APPLICATION FOR PERMISSION  
UNDER SECTION 16 OF  
THE TOWN PLANNING ORDINANCE  
(CAP.131)

Applied use/ development 申請用途/發展	Temporary Eating Place for a Period of 3 Years

PROPOSED TEMPORARY  
EATING PLACE FOR A  
PERIOD OF 3 YEARS

**(S.16 Planning Application No. A/YL-MP/342)**

BLOCK PLAN

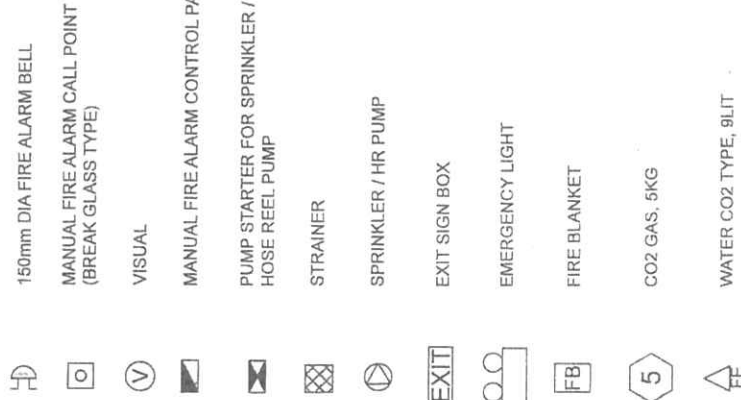
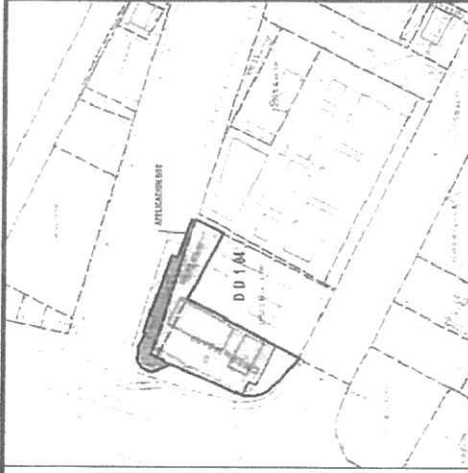
(a)	All proposed FSIs shall be incorporated on the FSI proposal.	Noted. The applicant will submit a revised fire service installations proposal after planning approval has been obtained from the Town Planning Board.

(b)	Schematic drawings will not be vetted at this stage and shall be omitted from future submission.	
(c)	The standards and specifications of the proposed visual fire alarms shall be revised as "the FSD Circular Letter No. 2/2012 and the Design Manual: Barrier Free Access 2008".

(d)	The standards and specifications of the proposed directional and exit signs shall be revised as "BS 5266: Part 1 and the FSD Circular Letter No. 5/2008".

Fig.2

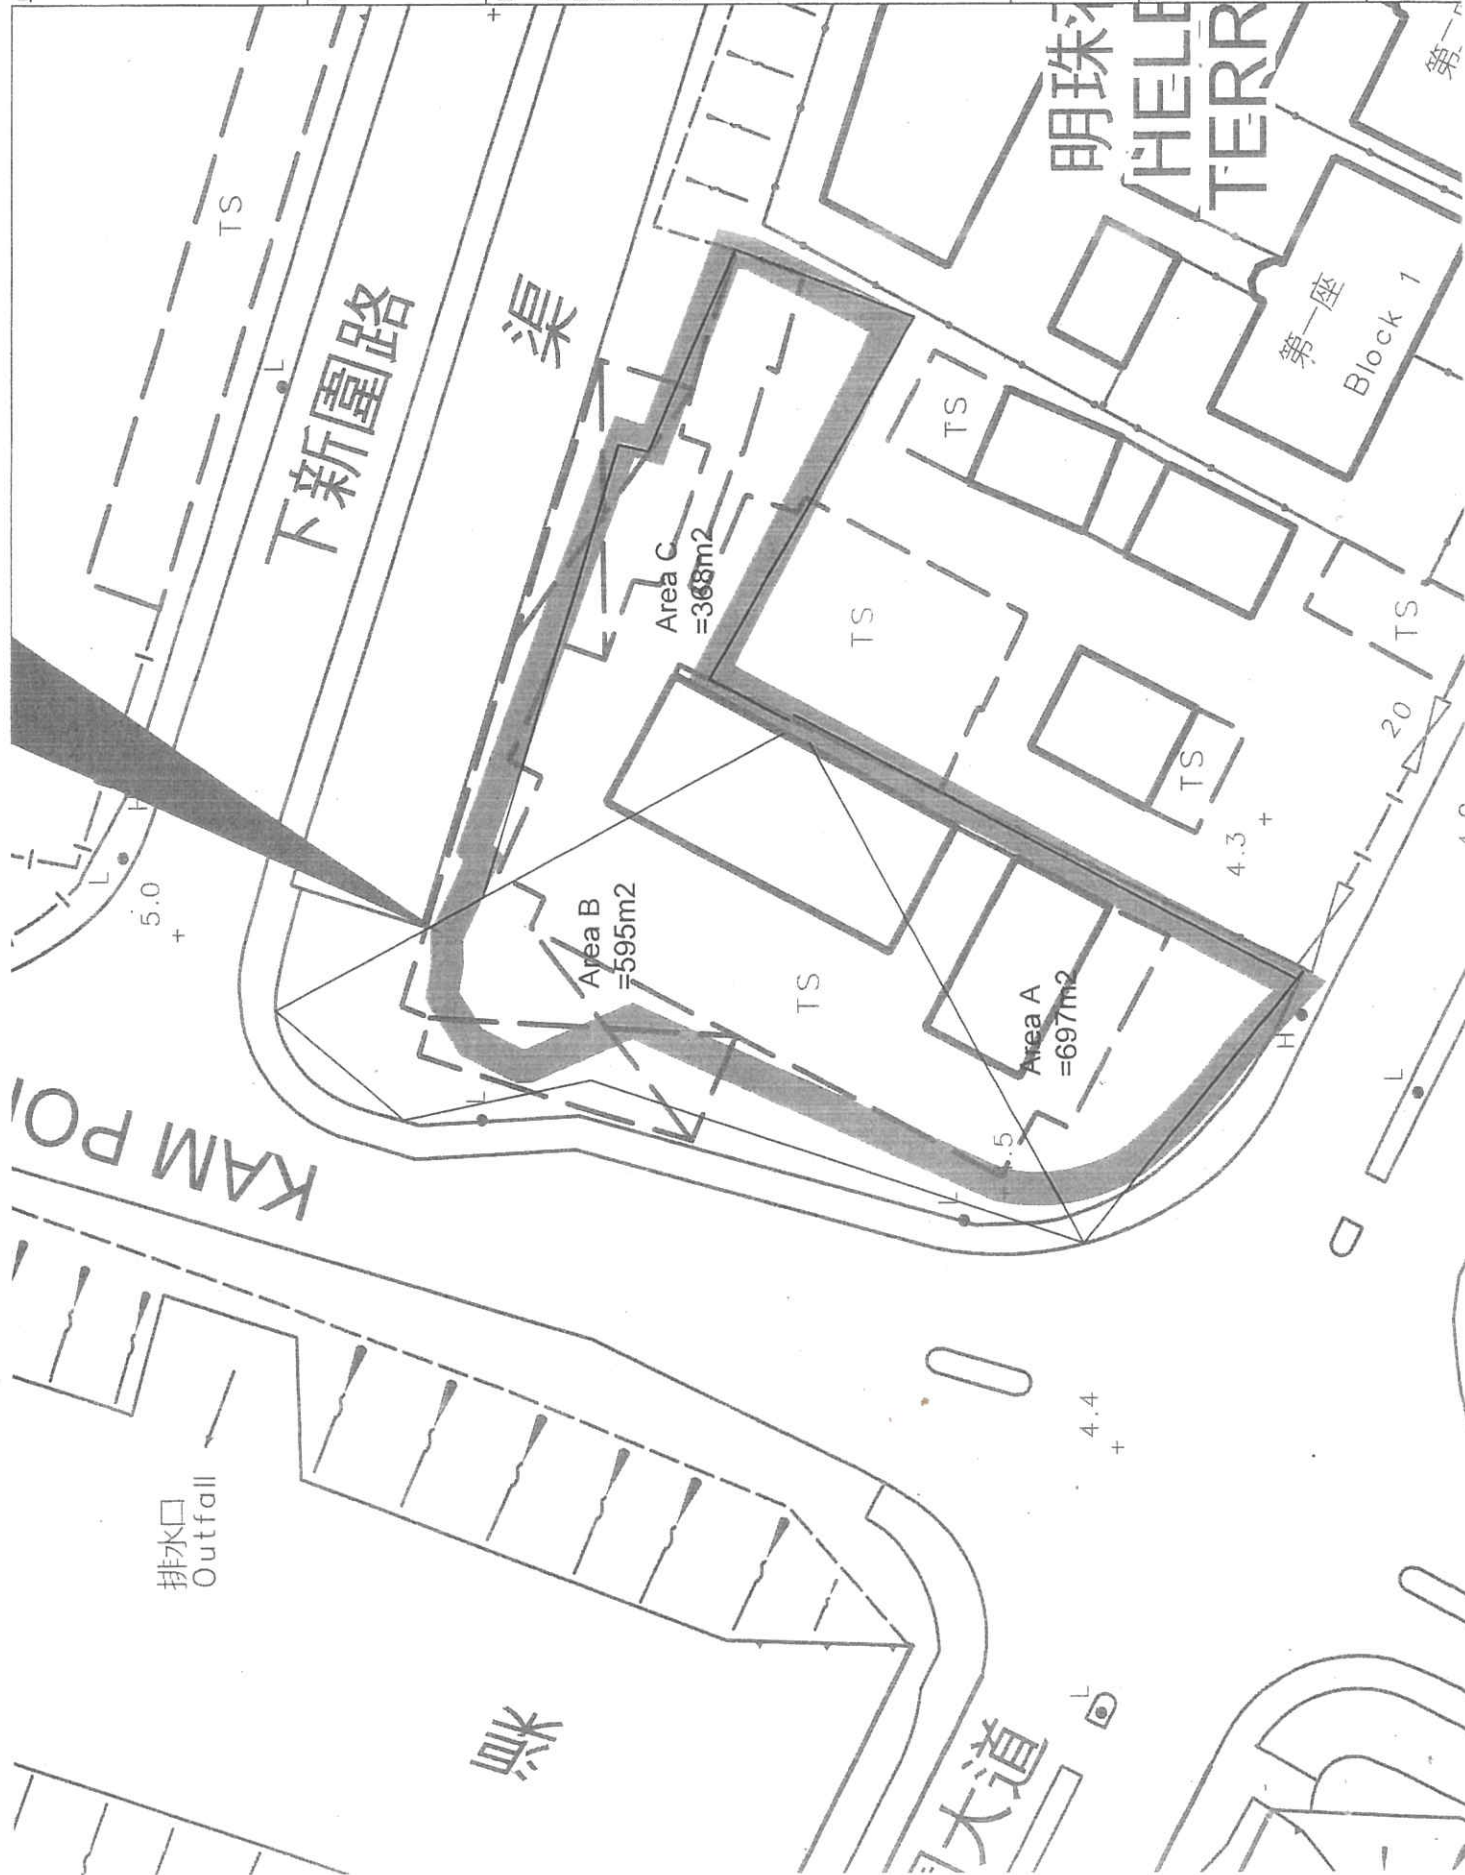
(a)	<p>In Figure 2, please provide the justification of the partition of three catchment areas. The catchment areas should depend on the geography and topography of the areas.</p>	<p>Noted. The applicant will submit a revised drainage proposal, with provision of peripheral u-channels and catchpits to mitigate potential adverse drainage impact generated by the proposed development after planning approval has been granted from the Board.</p>

flow from the adjacent lands should not be affected.	drainage facilities at the Site once the drainage proposal is accepted by DSD/the Board.
(c)	According to Area A and calculation chart, the existing 150UC is determined to be undersized. Please review and revise.

Drawing No.	P04
Ver.	01
Project	PROPOSED TEMPORARY EATING PLACE FOR A PERIOD OF 3 YEARS
	LOTS 3250 S.B. ss.24 S.A. RP AND 3250 S.B. ss.34 RP IN D.D. 104, AND ADJOINING GL MAI PO, YUEN LONG, NEW TERRITORIES

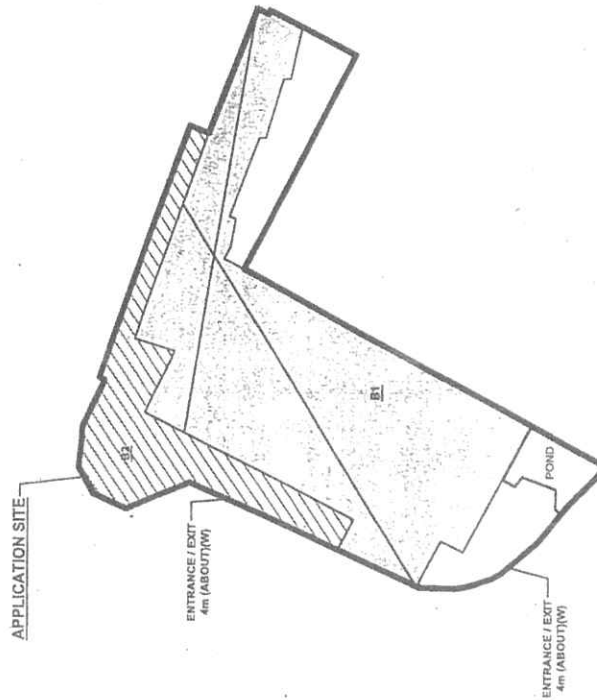
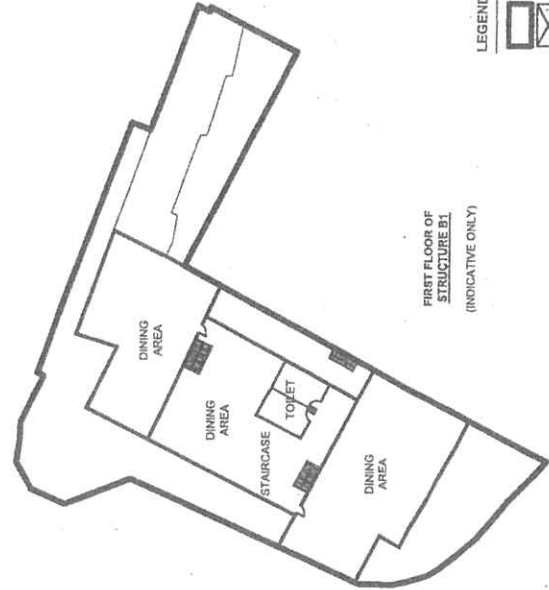
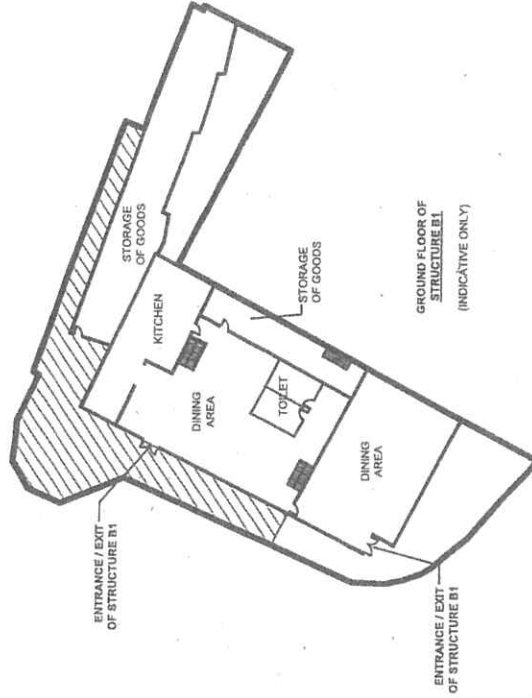
(a)	Please be advised that part of the Fairview Park Boulevard as shown coloured yellow in the attached plan is maintained by HyD. Please provide a detailed layout plan to clearly indicate the location of the vehicular access.	Please be confirmed that no parking and loading/unloading (L/UL) space is proposed at the application site (the Site), hence, no vehicular access is provided. Staff and visitors are required to access the Site by walking.

(a)	The applicant should clarify the access to the subject site in view that right turn from the Fairview Park Boulevard at its junction with Kant Pok Road is prohibited. In	The existing entrance/exit is located at the southwest portion of the Site which is accessible from Fairview Park Boulevard. Please be confirmed that no private car parking
